HISTORIC AND DESIGN REVIEW COMMISSION

HDRC CASE NO: 2024-110
ADDRESS: 134 E MULBERRY AVE
LEGAL DESCRIPTION: NCB 1702 BLK 6 LOT 9, W25 FT OF 10
ZONING: R-4, H
CITY COUNCIL DIST.: 1
DISTRICT: Monte Vista Historic District
APPLICANT: Alberto encinia/a. e. secure investments corp
OWNER: Charles Gonzales/GONZALEZ LINDA LOPEZ & CHARLES
TYPE OF WORK: New construction of a rear accessory structure
APPLICATION RECEIVED: March 27, 2024
60-DAY REVIEW: April 29, 2024
CASE MANAGER: Rachel Rettaliata

The applicant is requesting a Certificate of Appropriateness for approval to construct a 1-story, 655-square-foot rear accessory structure.

1 RELATION BETWEEN EXISTING AND NEW STRUTURE ON SITE

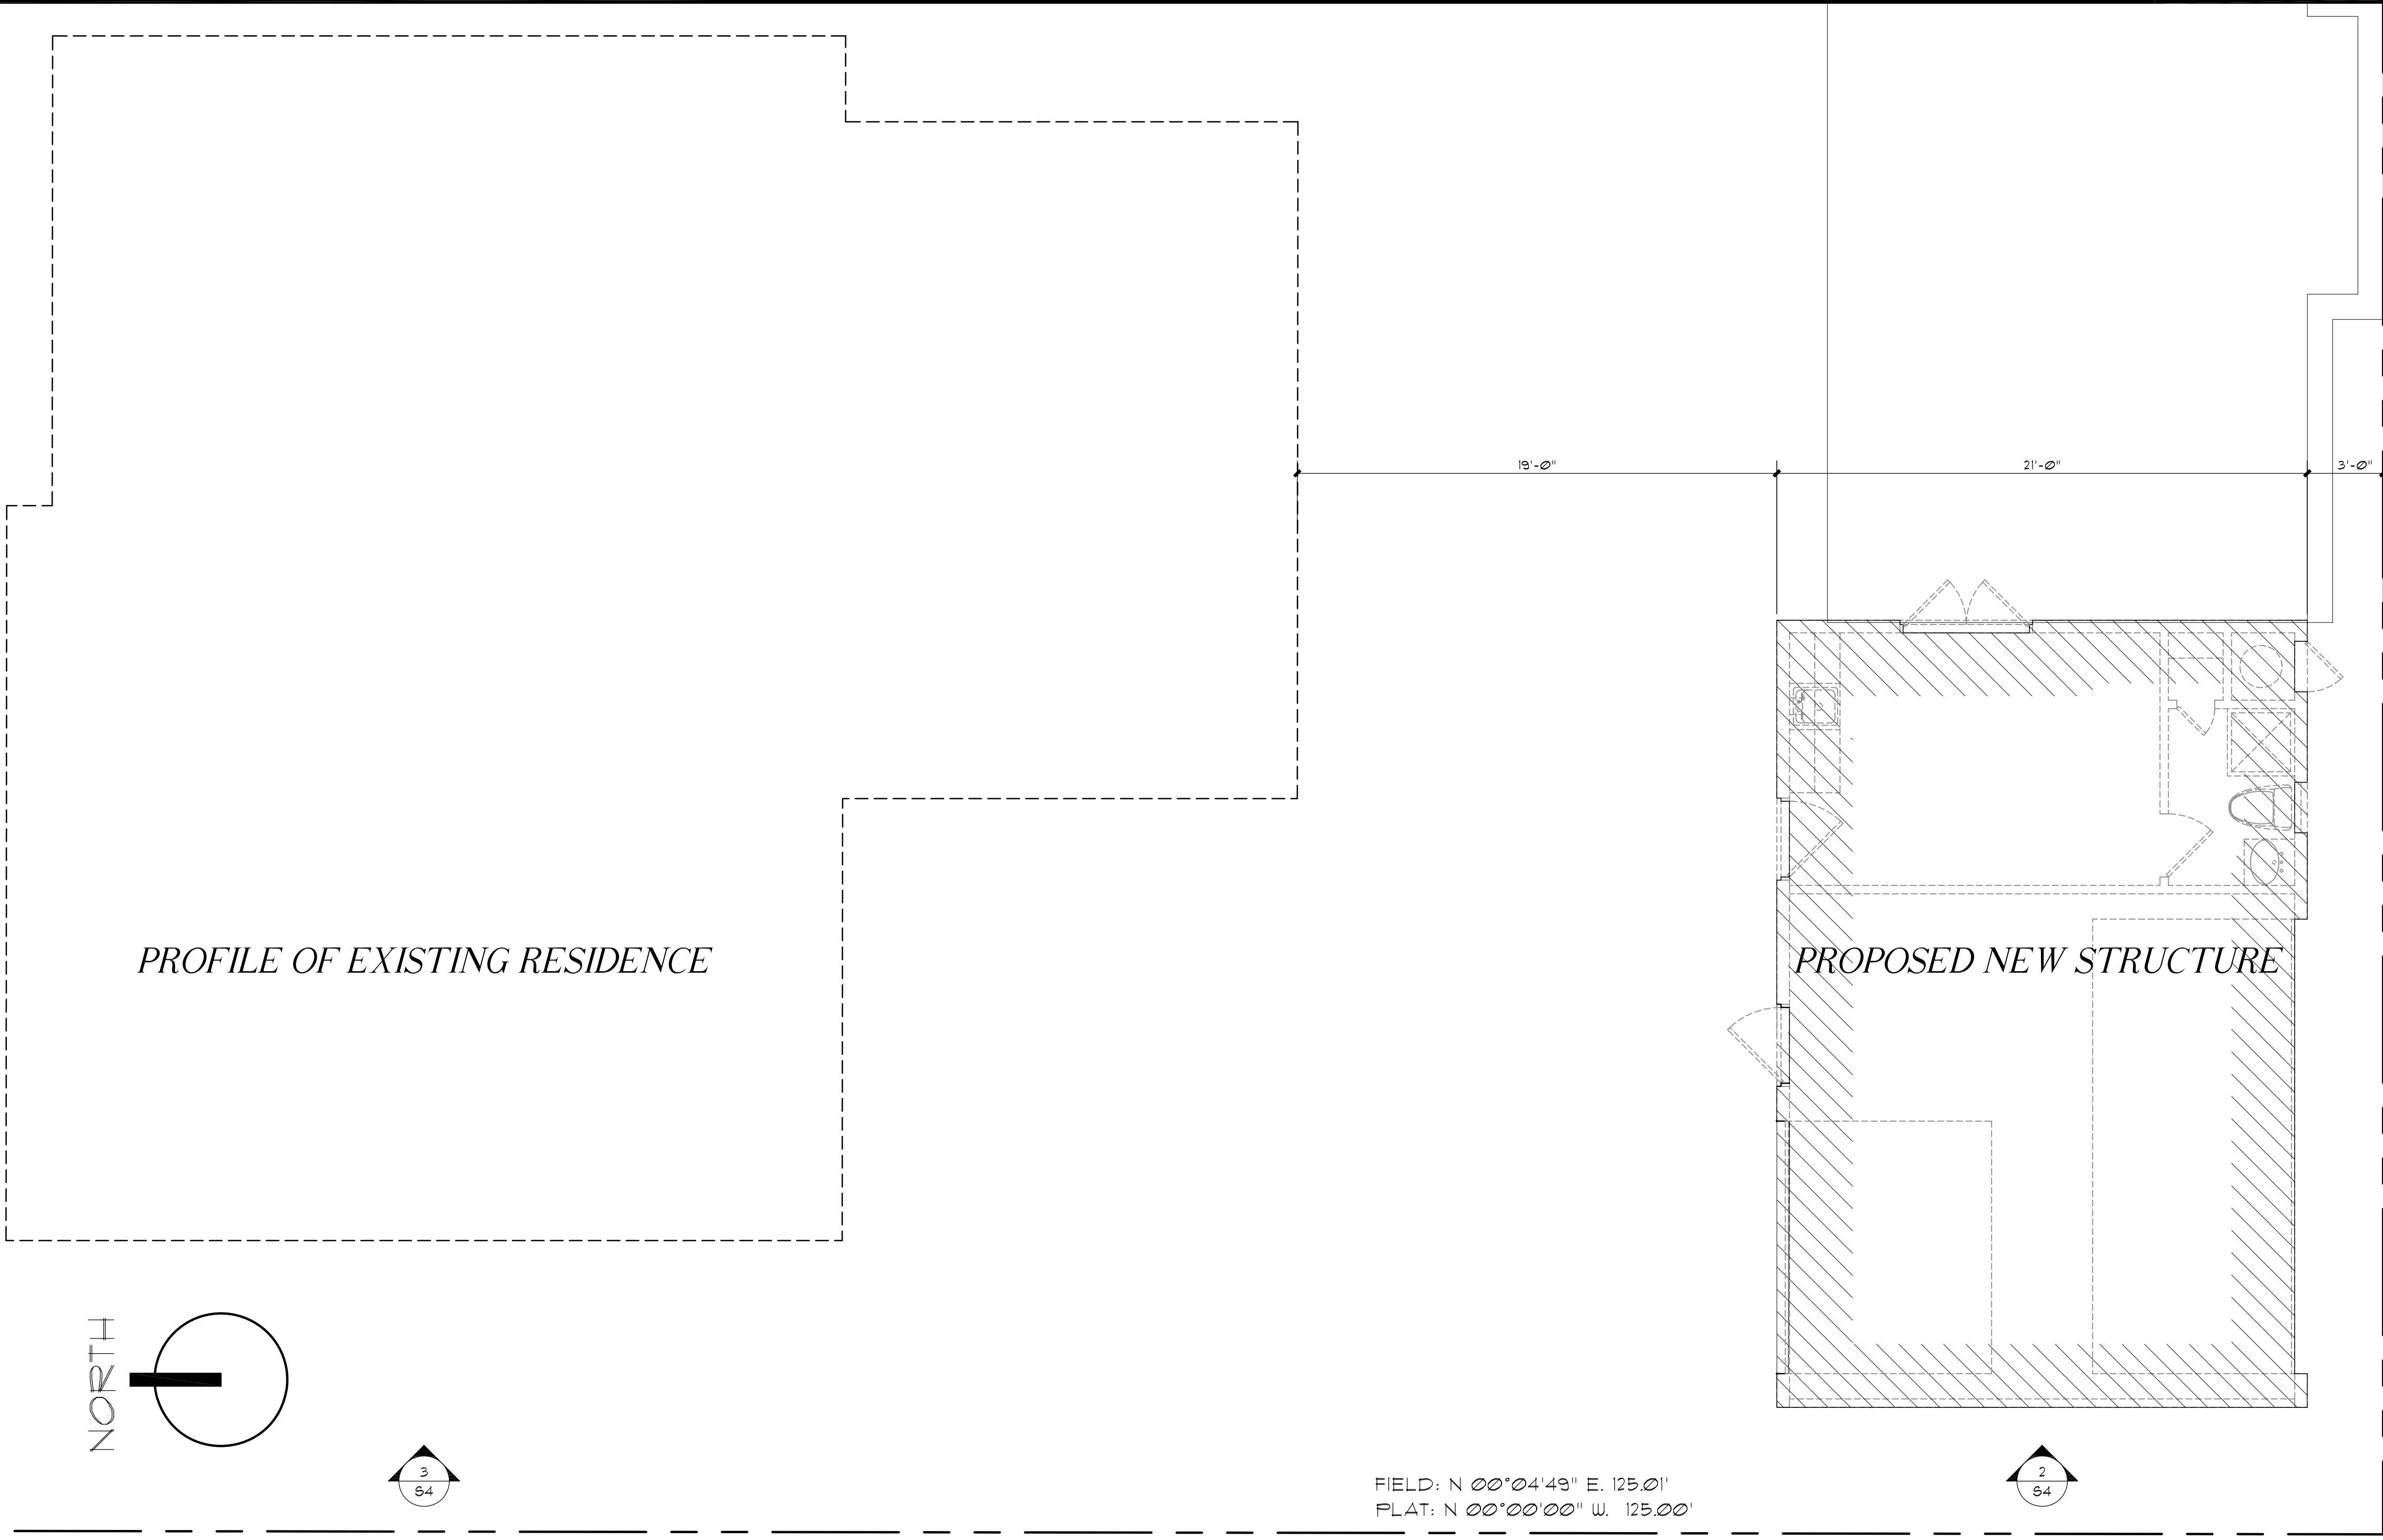
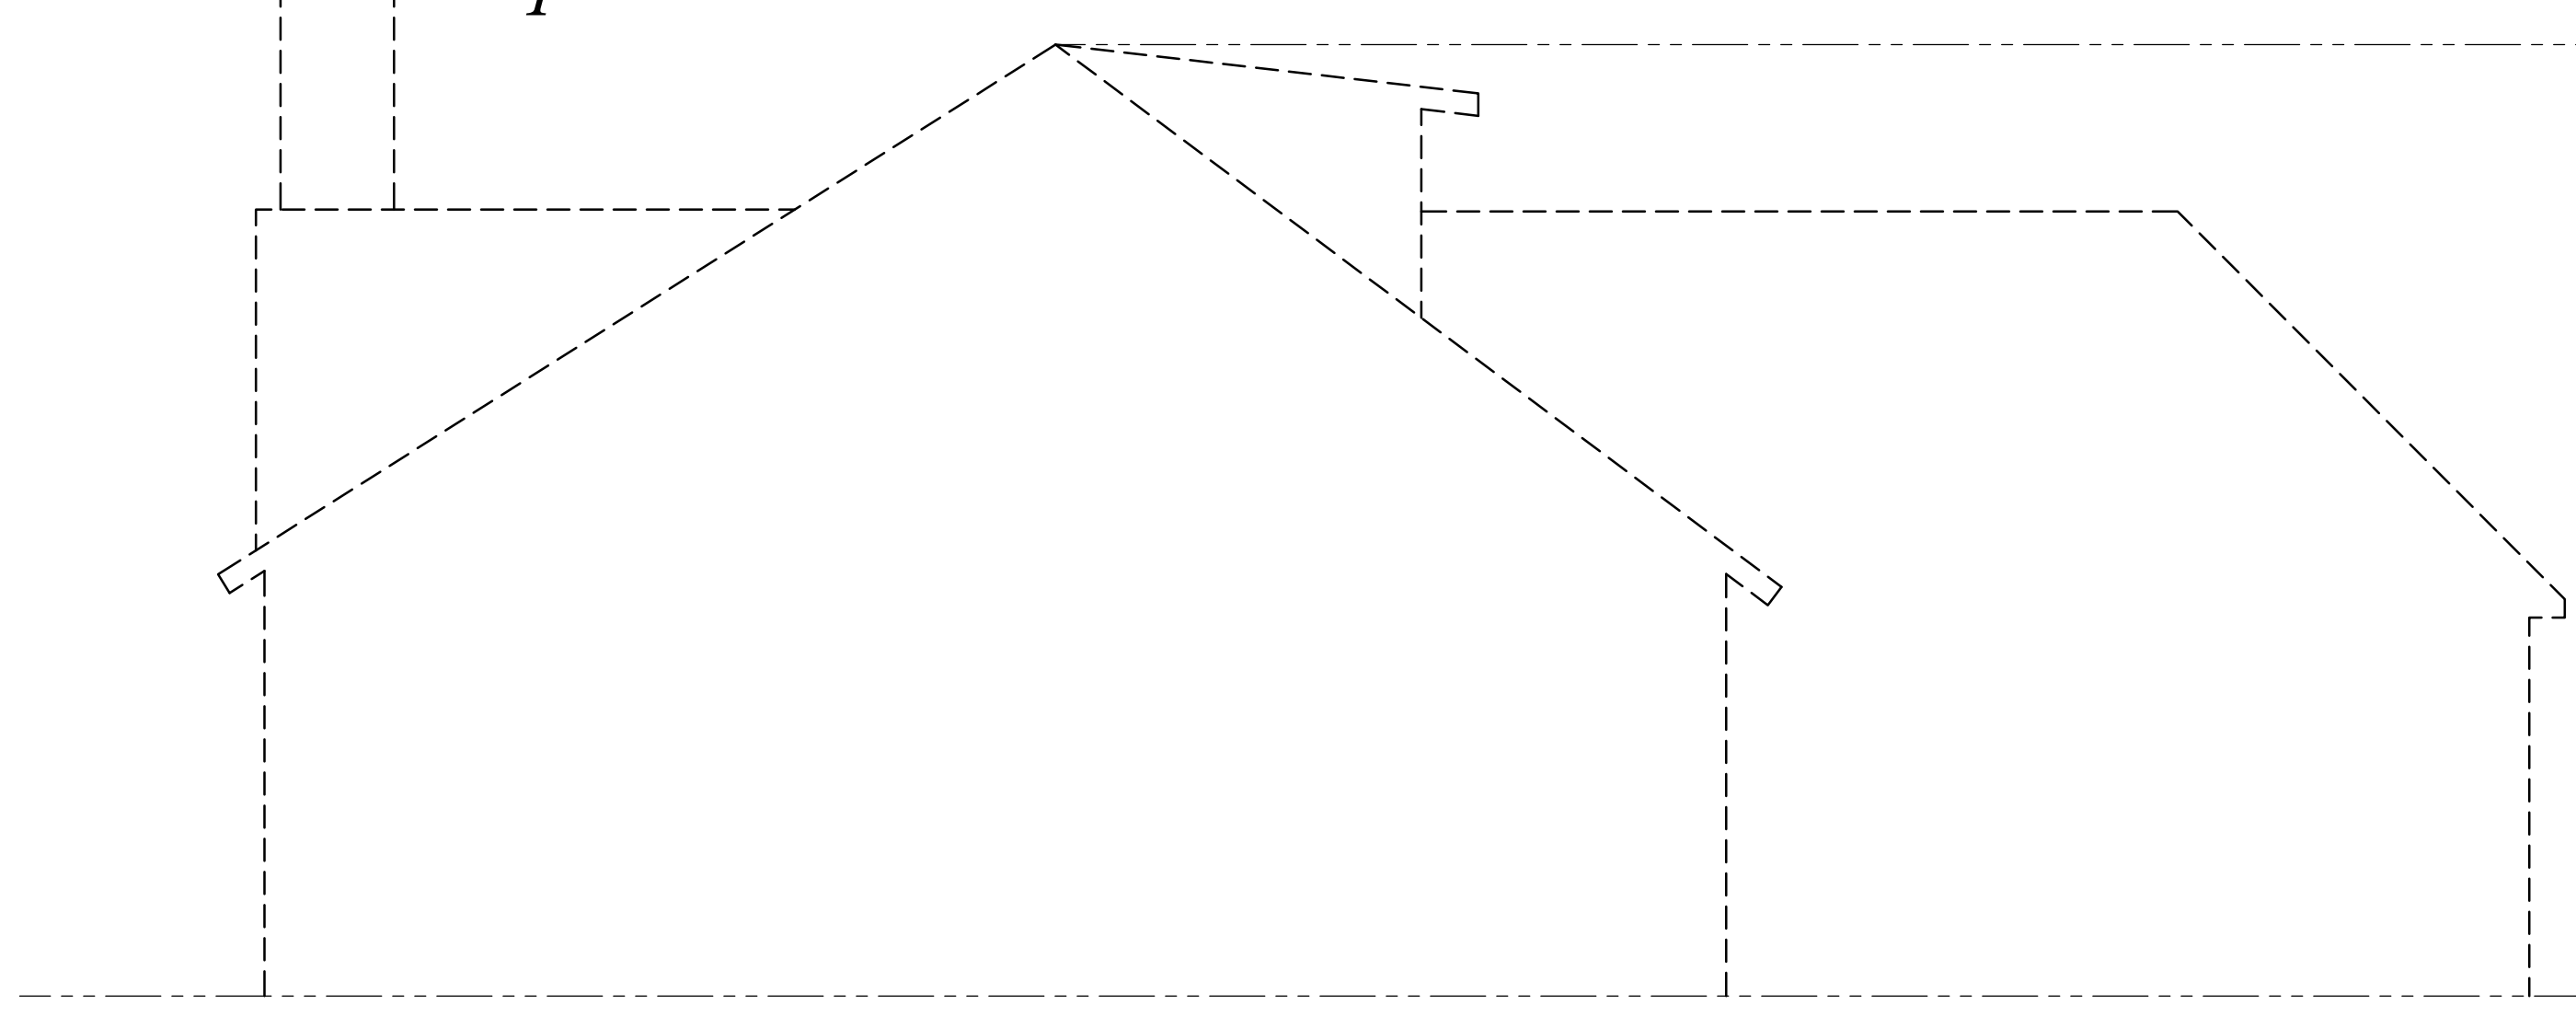
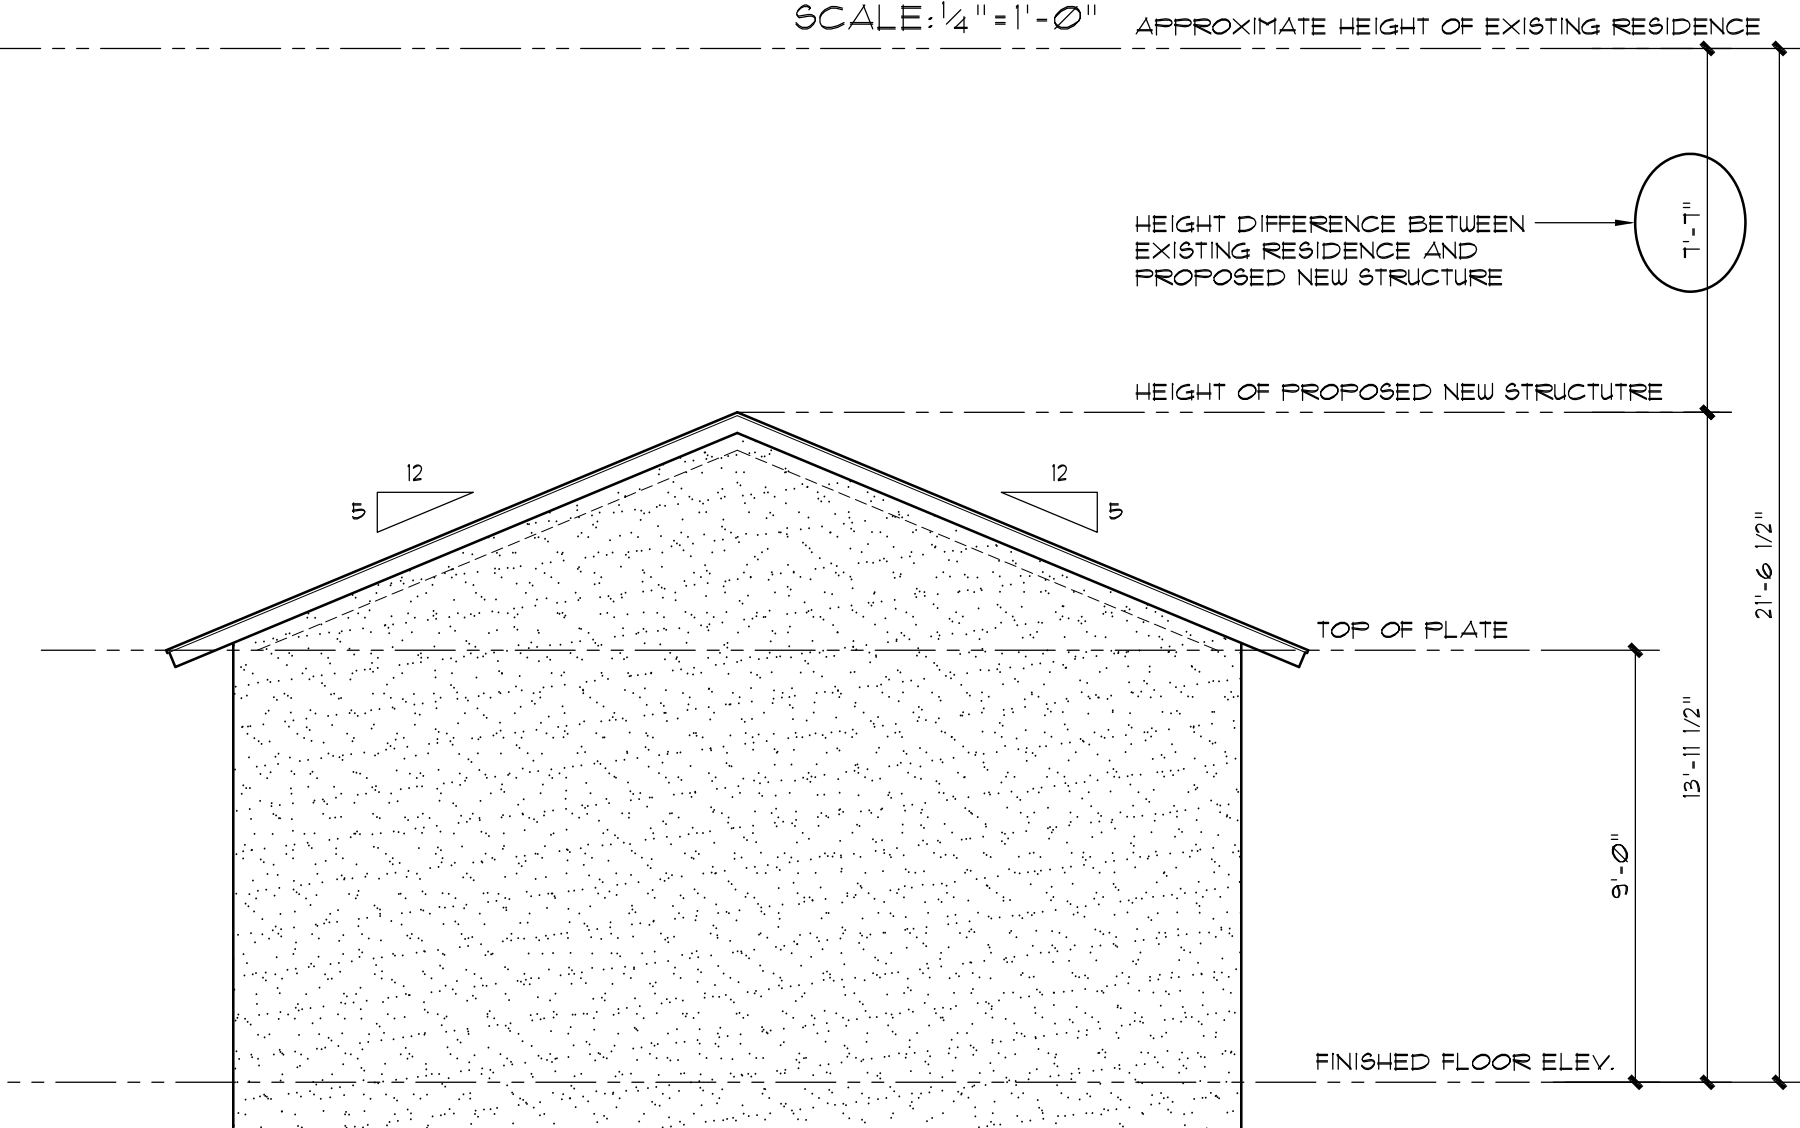
- e. **SCALE & MASSING** – The Guidelines for New Construction 5.A. notes that new garages and outbuildings should be visually subordinate to the primary historic structure in terms of their height, massing, and form, and should be no larger in plan than forty percent of the primary historic structure’s footprint. The existing primary structure on the lot features a footprint of 1,940 square feet and is two stories in height. The proposed accessory structure features a total footprint of approximately 655 square feet, or approximately 34% of the primary structure’s footprint. The applicant has proposed a top plate height of 9 feet and a total height of 13'-11.5". Accessory structures on the block are predominately single story, though some two-story accessory structures are present in the neighborhood. Staff finds the proposed general massing conforms to the Historic Design Guidelines, and the request is appropriate.

- f. **ORIENTATION & SETBACKS** – The applicant has proposed both an orientation and setback for the new accessory structure that are consistent with the Guidelines for New Construction 5.B.
